The Greater Cambridge Design Review Panel

Pre-application

Clarendon House, Clarendon Road, Cambridge, CB2 8BH

Thursday 28 September 2023, Hybrid meeting

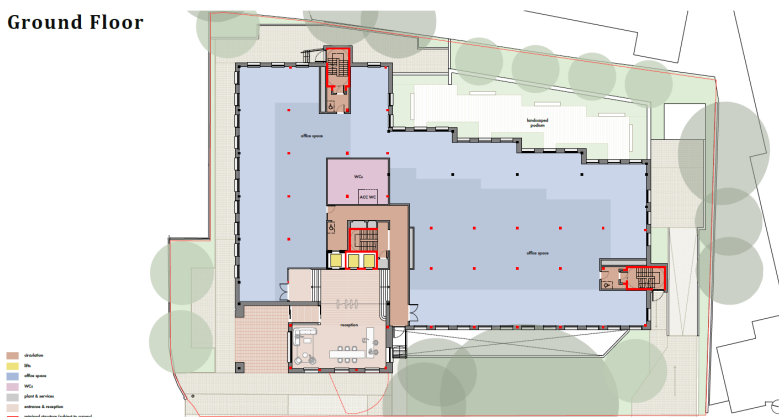
The Panel were concerned that the location of the heat pumps at the lower ground floor could lead to issues where the cold air connected in the semi-basement. The applicants agreed that this would need to be checked and it may be necessary to supplement the air movement in this area.
